Supplemental Commission Agenda Report

Planning Commission Meeting
09-08-26
Item 3.B.5.

Subject: De Minimis Waiver No. 26-005 – An application for a new pool and spa to be used for fire suppression purposes for a parcel affected by the Woolsey Fire

Revised[1] De Minimis Waiver

POOL PLAN AND DETAILS

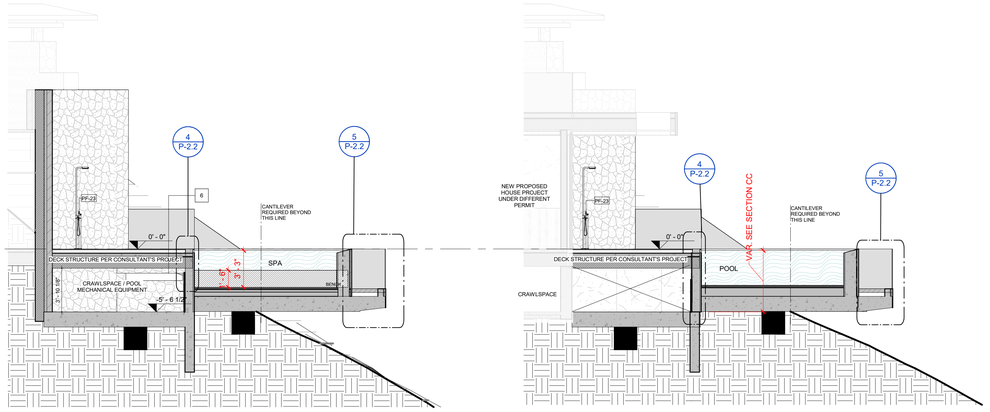
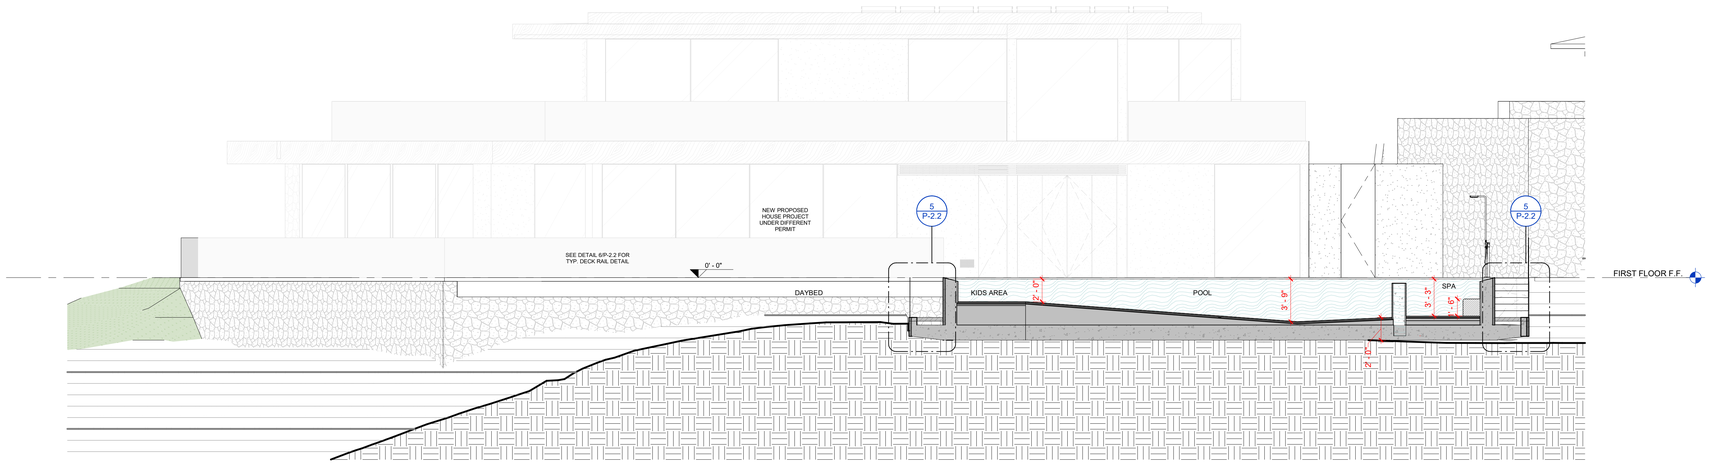
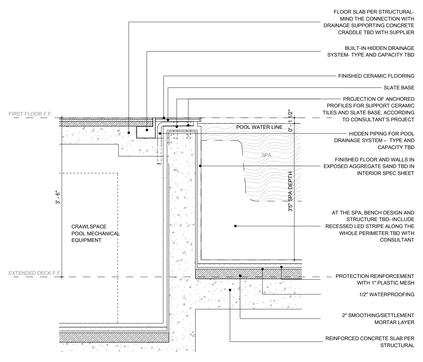
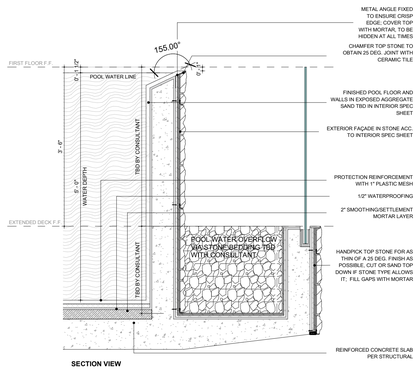
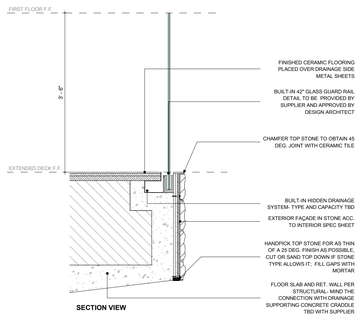
22. Sheet P-2.1 of the Studio Arthur Casas plans dated 6-9-2025 depict a proposed outdoor shower. A note shall be incorporated into the project plans stating: “The proposed outdoor shower shall not drain to the existing onsite wastewater treatment system (OWTS).”

4) **Proposed Pool Shower Note:** Sheet P-2.1 of the Studio Arthur Casas plans dated 6-9-2025 depict a proposed outdoor shower. A note shall be incorporated into the project plans stating: "*The proposed outdoor shower shall not drain to the existing onsite wastewater treatment system (OWTS).*"
